Shoreland Permit Applicationfor a **Shoreland Protection Permit** under
Chapter 49A of Title 10, § 1441 *et seq.*VERMONT DEPARTMENT OF
ENVIRONMENTAL CONSERVATION**WATERSHED
MANAGEMENT DIVISION**

For Shoreland Permitting Use OnlyApplication Number: 278**Public Notice:** At the same time this application is filed with Shoreland Permitting, a copy of this application must be provided to the municipal clerk for posting in the municipality in which the project is located.Submission of this application constitutes notice that the person in Section A intends to create impervious surface and/or cleared area within the Protected Shoreland Area, and certifies that the project will comply with Chapter 49A of Title 10, § 1441 *et seq.* All information required on this form must be provided, and the requisite fees (Section G) must be submitted made payable to the State of Vermont, to be deemed complete. Refer to *The Vermont Shoreland Protection Act - A Handbook for Shoreland Development* and related instructions for guidance in completing this application.**A. Parcel Information**1. Landowner's Name: **Ronald & Karen Cogliano**2a. Physical Address (911 Address): **254 Boys Camp Road**2b. Town

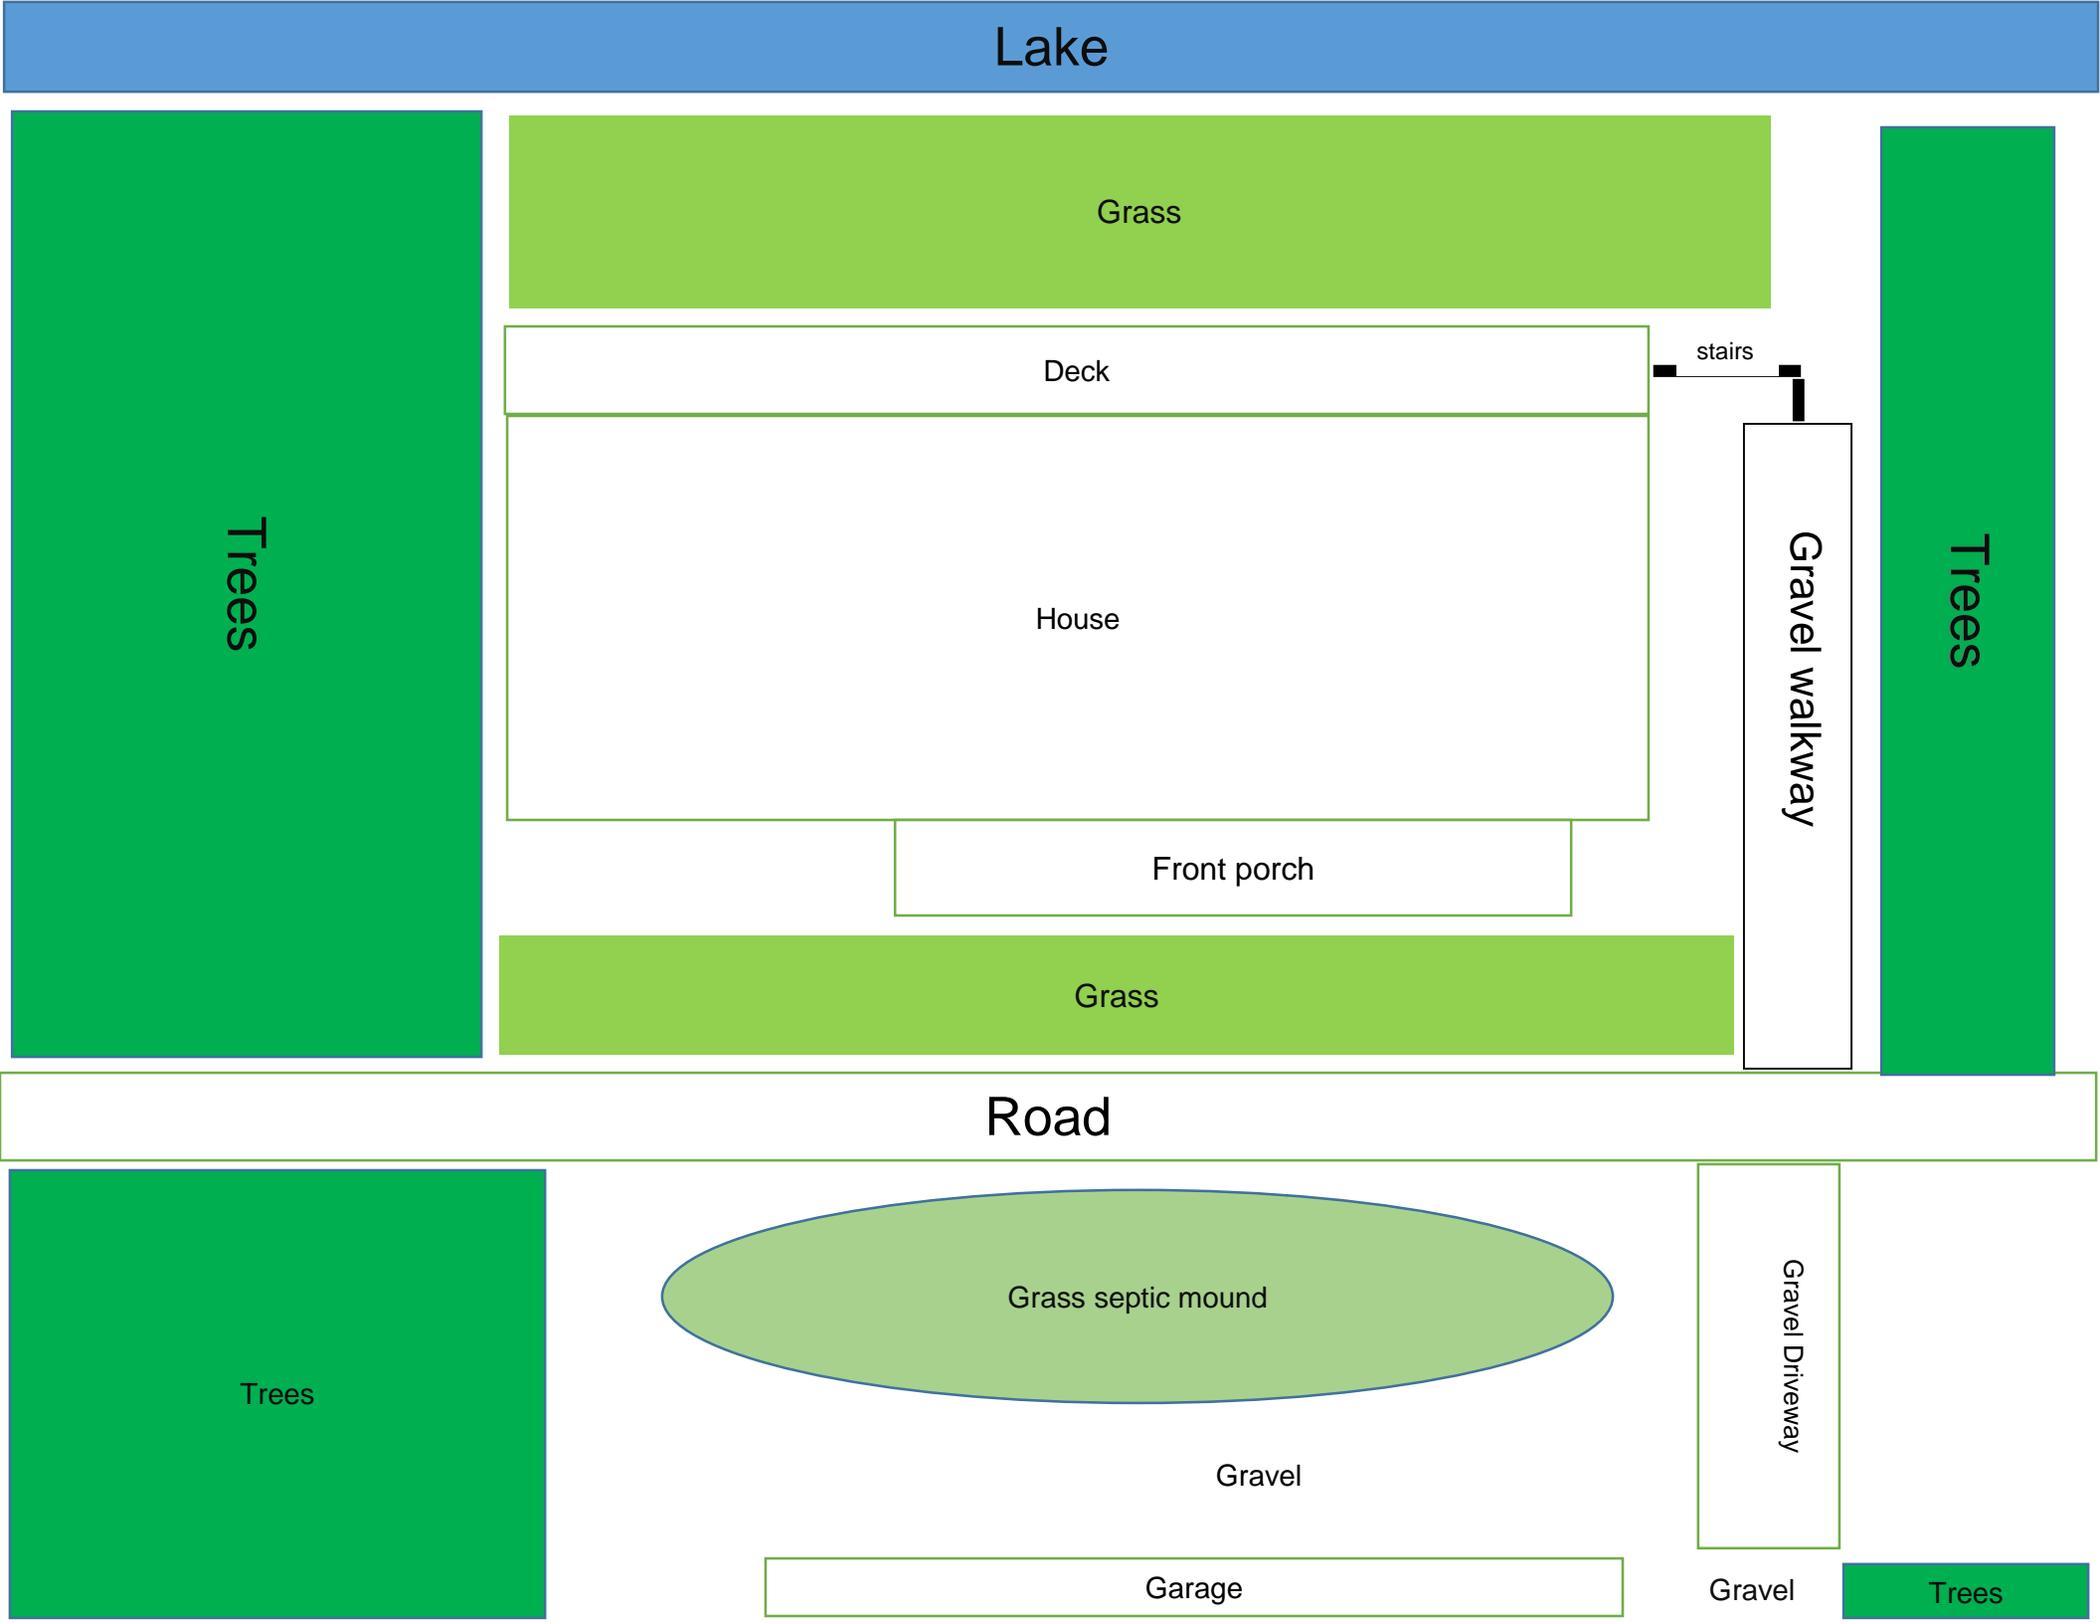
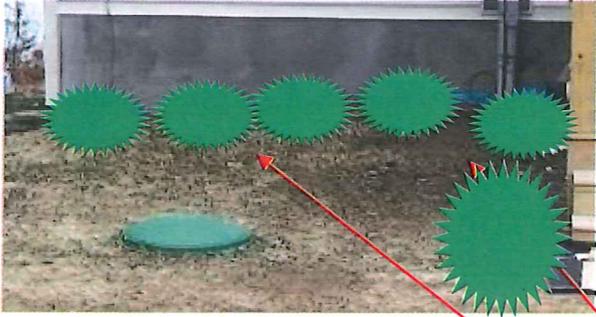
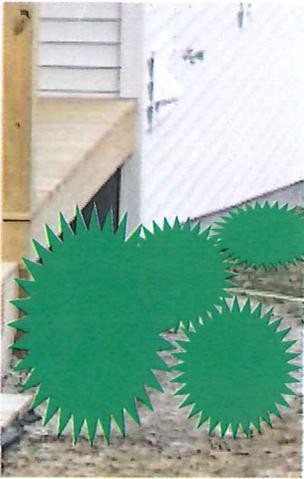
The public notice period for your application ends today, but the application remains incomplete until I receive the plot plan with all dimensions and distances from mean water level (including proposed cleared area and proposed revegetation area). Can you please provide this?

The more information the better, but the plot plan with all dimensions and distances from mean water level (including proposed cleared area and proposed revegetation area) should suffice.

I will attach this existing site plan with the application. However, as stated in Section D.1 under Project Description:

“For this application to be considered administratively complete you must attach site plans that denote existing and proposed cleared areas and impervious surface and their distances from mean water level, no fewer than three photos of the project area, and dimensions and associated surface areas of cleared areas and impervious surfaces.”

So we need the measurements and dimensions on the site plan, including for the proposed cleared area.

Notes:

- Proposed tree removal approximately 248 feet from mean water line.
- Area of new plantings equals or surpasses 548 square feet and includes shrubs, annuals and perennials
- Home is approximately 62 feet from water

Approximation of proposed plantings in front of house and on roadside septic mound to mitigate newly-cleared area

FYI - the new plantings around the house make up 248' of the total 548' feet of plantings and occur beginning 62' from the water and run up along either side of the house and around some of the front. Also, I am planting some junipers and hostas along the side of the state approved septic mound, which is just across the right of way on the map (attached) as the slope on this piece is brutal. Currently is it grass, but that will change this spring/summer.
